- A. Fuel Line Kinking –
1987-88 Model 3 Cylinder 70-75-80-90-HP
- B. E.C.U. Harness Coupling Ring – V220 EFI
- C. Gear Housing Change – Mariner 25 (695)
and 30 (689)
- D. Propeller Shaft Change – Mariner 25 (695)
and 30 (689)

Figure 1. Molded Hose Kit Installed

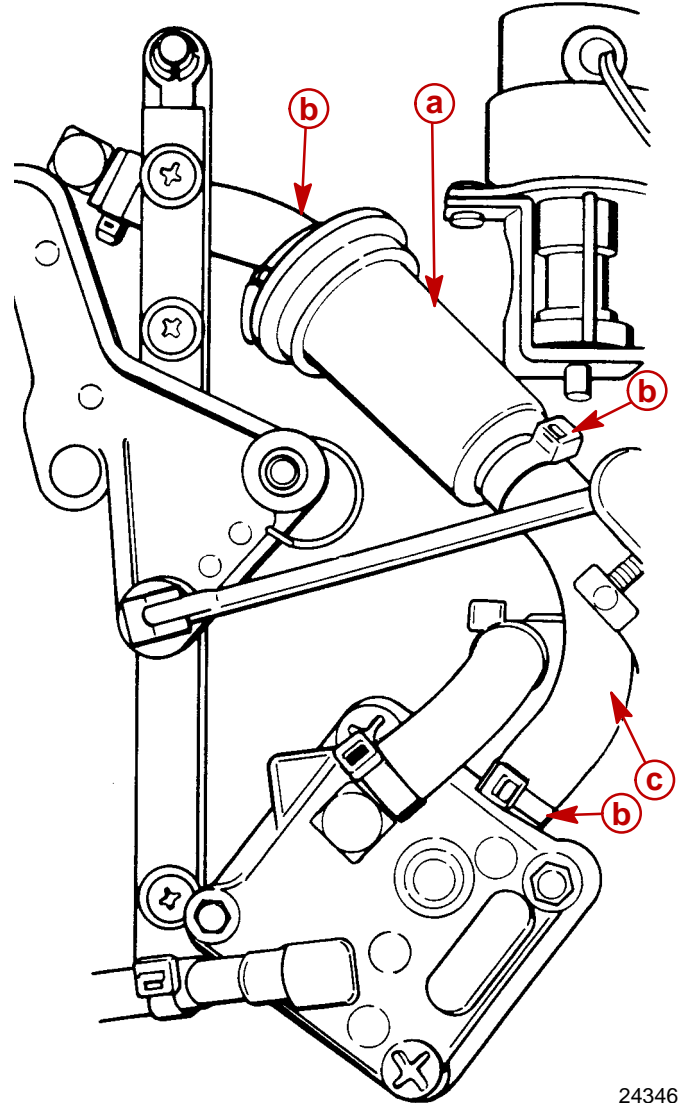
On 1987-88 3 cylinder (70-75-80-90 HP) the fuel line between the fuel pump and fuel filter may kink and restrict the fuel supply to the carburetors. Should this occur, replace the original fuel line with Molded Hose Kit P/N 32-19017A1. (Figure 1) Kit contains a molded fuel line and a replacement fuel filter.

Production models serial number B311188 and above will have the molded fuel line installed.

Figure 2.

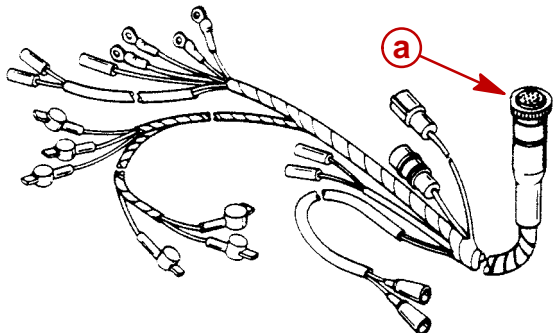
Should the harness coupling ring (Figure 2) break when connecting the E.C.U. harness to the E.C.U. box it can now be replaced. Order Part Number 19049. The replacement coupling ring easily snaps into place on the harness.

Figure 3. Inspection Area

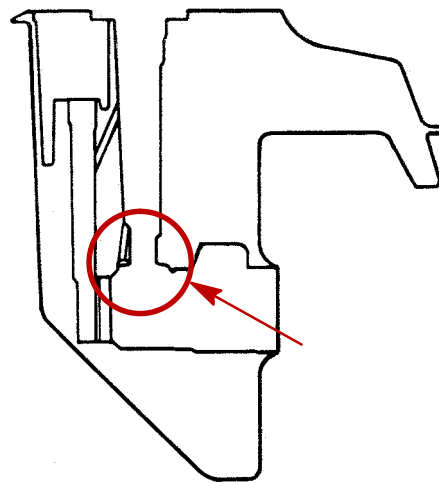
Thrust washer (P/N 12-81624M) above the pinion gear is no longer used on thru prop exhaust models listed. The complete gear housing assemblies are interchangeable as a unit. The empty gear housing (P/N 1651-9362M) is also interchangeable with previous models. however, inspection (Figure 3) is required to determine if the thrust washer is used.

Figure 4. Previous Gear Housing

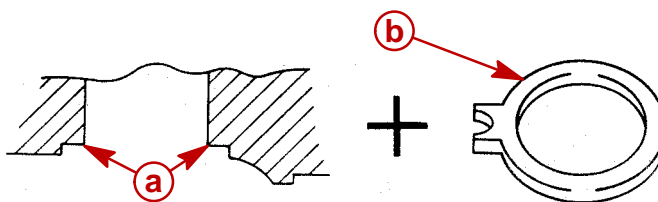
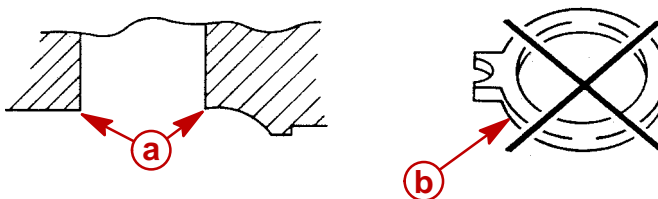
Gear housing with recess (Figure 4) machined into casting above the location of the pinion gear requires the installation of thrust washer (P/N 12-81624M). Gear housing without machined recessed (Figure 5) does not require the thrust washer and one must not be used. Shimming specifications remain the same.
